TECHNICAL SERVICE BULLETIN

Technical Service Bulletin: 51-0956

LCI 8800 SERIES WINDOW REPAIR

TSB Number:	15-001-19
Product:	LCI Window Repair
Date:	May 20, 2019

Fig. 1

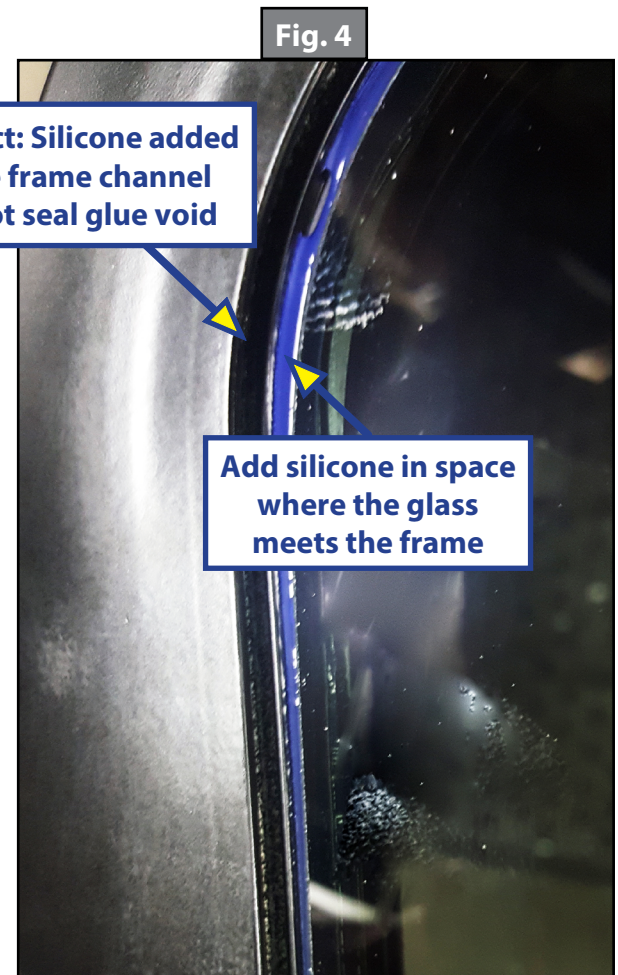
1. **Vinyl:** Vinyl (Fig. 1) is a rubber seal to function as an initial water management barrier.

If the vinyl is damaged when it is removed and it cannot be reused, please order replacement vinyl (LCI Part # 213162) online by visiting <https://store.lci1.com>.

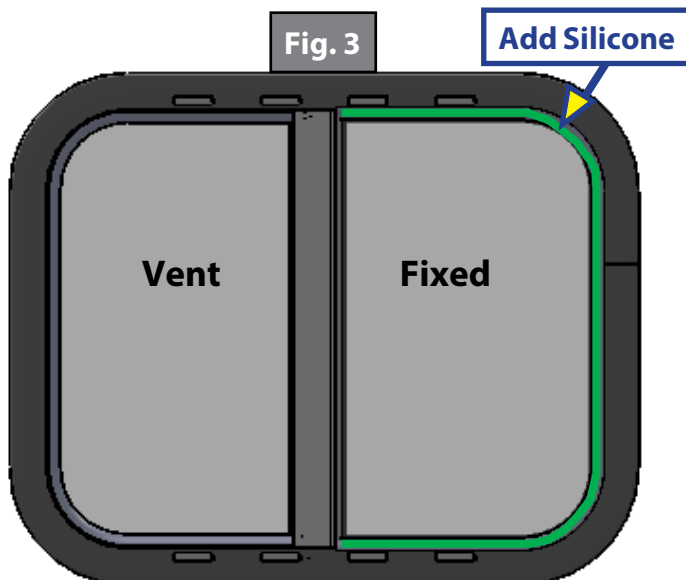
1. Pull out vinyl located around the outer perimeter of the fixed glass (Fig. 2) and save for reuse in areas not covered by a glazing bar.

NOTE: Do not remove vinyl on the mullion side of the glass (Fig. 2).

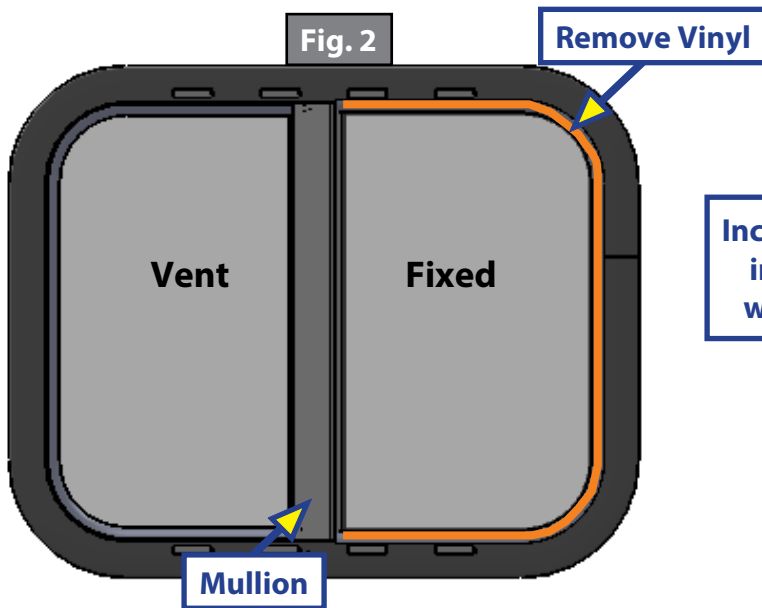
2. Run a bead of 100 percent silicone around the outer perimeter of the fixed glass (Figs. 3 and 4).
3. Reinstall the vinyl that was removed.
